NEW MEXICO ENVIRONMENTAL LAW CENTER

RE: Uranium Recovery GEIS; Draft GEIS Comments

RE: Uranium Recovery GEIS; Draft GEIS Comments

Figure 1

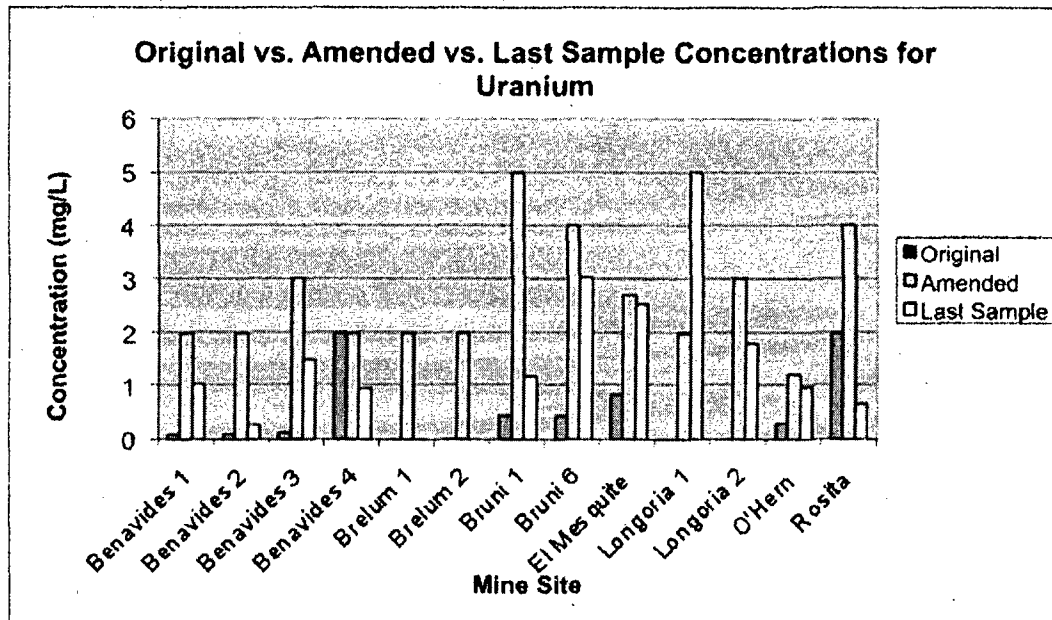
- In all but two cases (Benevides 4 and Rosita), the Amended Restoration Table Values and the Last Sampled Concentrations of uranium for the Production Areas listed on Figure 1 (next page) exceed the Original Restoration Table Values approved by TCEQ.
- The Primary Drinking Water Standard (PDWS) for Uranium is 0.03 mg/l (or 30 µg/l).
- In all cases, the Amended and Last Sampled Concentrations of uranium exceed the PDWS.
- The higher Amended Restoration Values and the Last Sampled Concentrations are results of the inability of site operators to reduce uranium concentrations based on their respective proposed groundwater restoration programs. This calls into question the operators' understanding of the geochemistry of the hydrogeologic systems that they are exploiting.

Figure 2

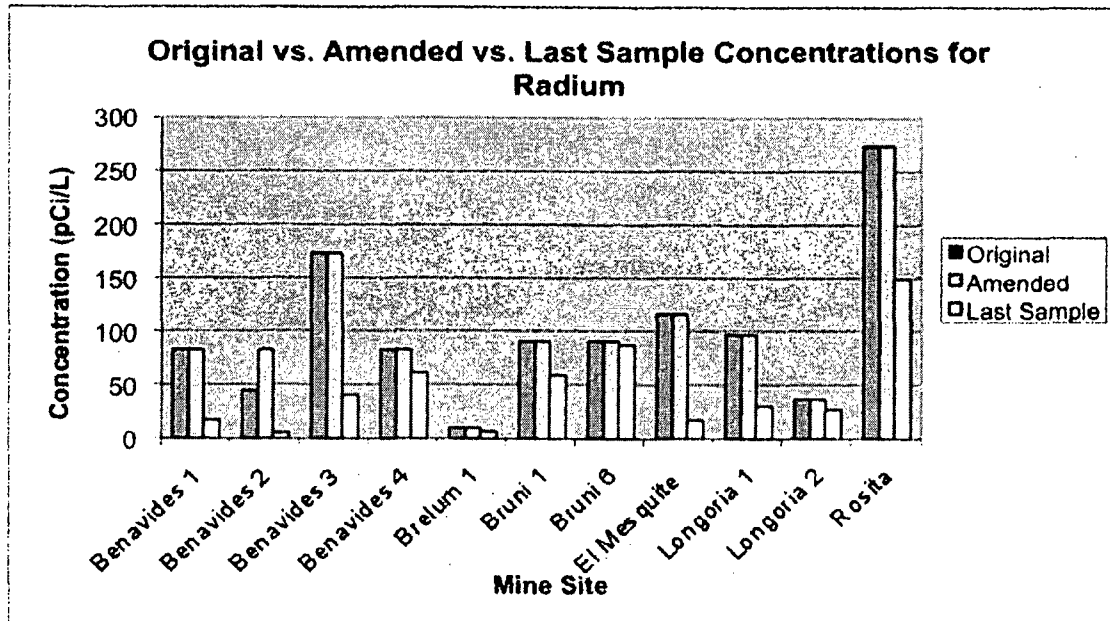
- All of the 12 Last-Sampled values were less than the Original Restoration Target Values (Attachment F).
- In all cases, radium-226 of the Amended Restoration Tables and Last Samples exceed the combined radium-226 and radium-228 PDWS of 5 picocuries per liter (pCi/L) (Attachment F; Figure 2, next page).
- The Original Restoration Table Values of radium-226 also exceed the radium-226/radium-228 PDWS of 5 pCi/L (Attachment F). What has not been established is the range of pre-exploration background radium-226 activities because (1) the Texas Water Development Board seldom includes radiochemical data in its groundwater chemistry database, and (2) the operators' methods of exploration have not been demonstrated not to destabilize uranium orebodies enough to release uranium and daughter products in sufficient concentrations and activities above

true background and pre-mining levels. In other words, adequate pre-exploration background studies have not been conducted.

Figure 3

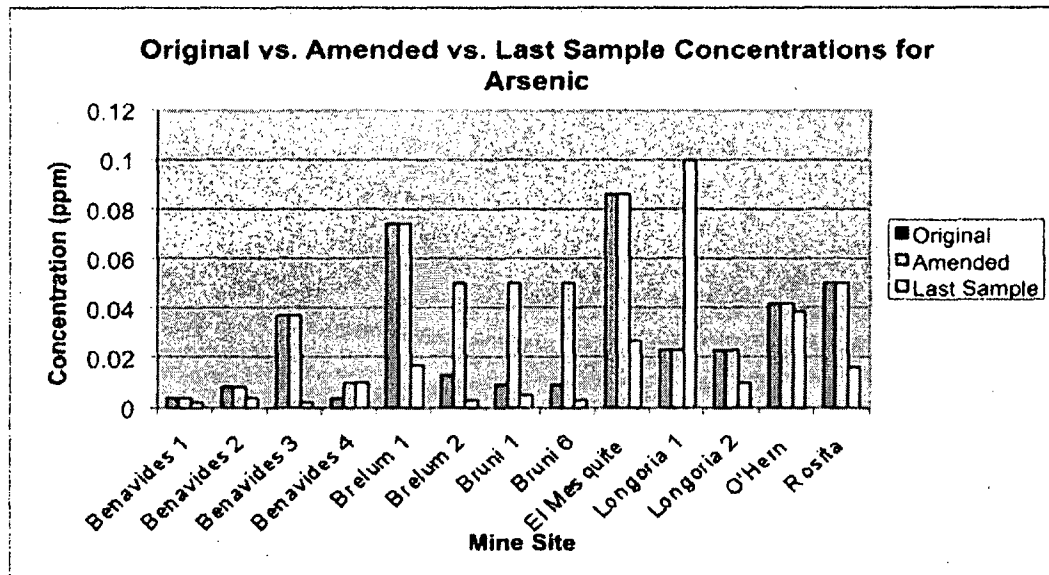
- In 53 of 73 cases, the Original Restoration Target Values exceed the current PDWS of 0.01 mg/l (10 µg/l) (Attachment G).
- In 25 cases, the Amended Restoration Target Values exceed the 53 Original Restoration Target Values (Attachment G).
- Seven of the 13 Last Sample Values are either equal to or greater than the PDWS of 0.01 mg/l (10 µg/l) (Figure 3, next page).
- The previous PDWS for arsenic was 0.05 mg/l.
- At 12 of the Production Areas, the Original Restoration Target Valued exceeded the old PDWS.

Figure 4

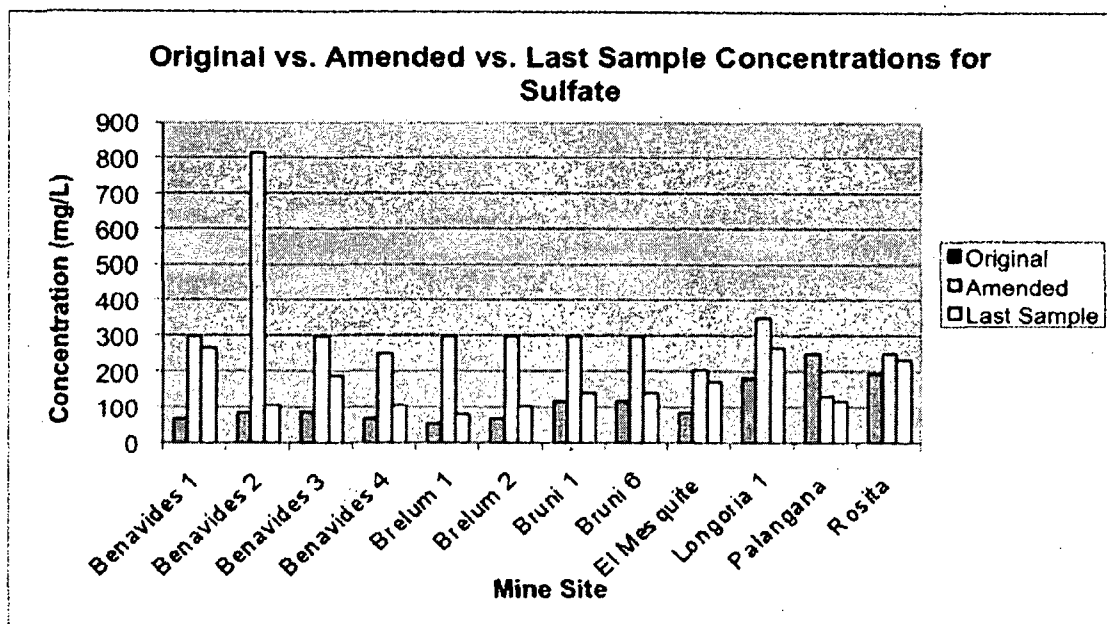
- With one exception, the Amended Restoration Target Values and Last-Sampled Concentrations of sulfate exceed the Original Restoration Target Values (Attachment H; Figure 4, next page).
- Although there is no PDWS for sulfate, the increased Amended and Last Sampled concentrations of sulfate underscore the potential for in-situ leach mining to increase major dissolved solids that affect the aesthetic properties of drinking water.
